UNITED STATES PATENT AND TRADEMARK OFFICE

APPLICATION NO.	FILING DATE	FIRST NAMED INVENTOR	ATTORNEY DOCKET NO.	CONFIRMATION NO.
10/690,660	10/23/2003	Heui Seag Park	1594.1243	8931

Office Action Summary

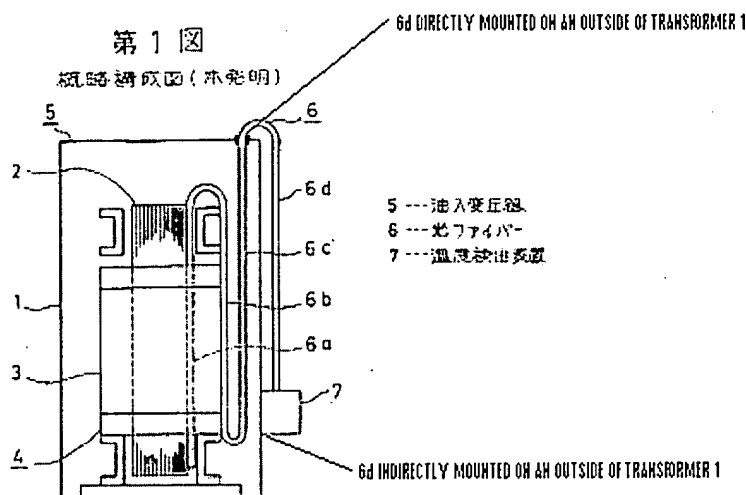
12. Applicant's arguments filed 04/05/05 have been fully considered but they are not persuasive.

Applicant argues that in Watanabe reference, the sensor 6d is not on the outside of the transformer tank1. The Examiner disagrees. In figure below shows that sensor 6d is mounted on an outside of the transformer.
